ISR Required Snocross snow flap retention

BULLETIN NO. 20/21-002 DATE: 16 Sept 20

SUBJECT: All Classes are required this snow flap construction

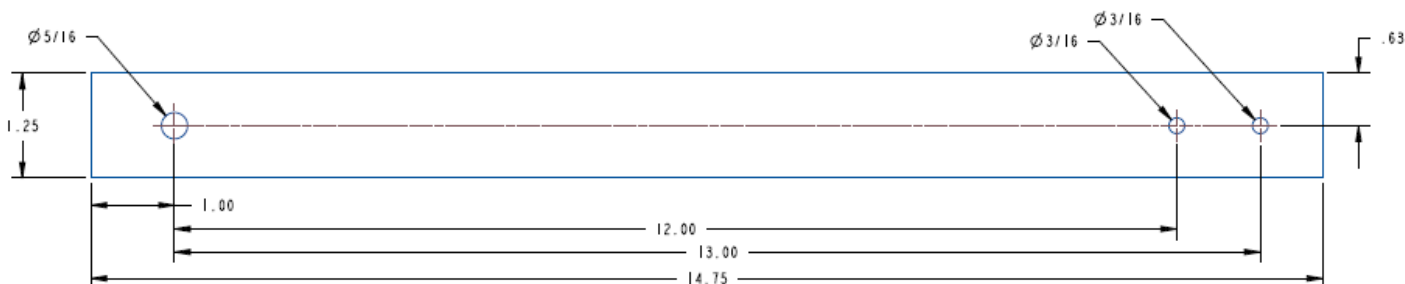
Take the limiter strap (5417676) and pick one of the inward 5/16" holes. From the center of that hole cut the strap off 1.0".

Then from the center of that same 5/16" hole measure down the opposite direction 12" and 13". Drill a 3/16" hole in both locations.

Once all holes have been drilled then cut the overall length of the strap to 14.750" long.

From each end of the rear bumper (see above picture for starting measuring point) measure up and make a mark at 21.125" and 22.125". Transfer the marks to the underside of the rear bumper. You will drill these holes in the rear bumper with a 3/16" Drill. The screws (7518280) will self-tap into the aluminum rear bumper.
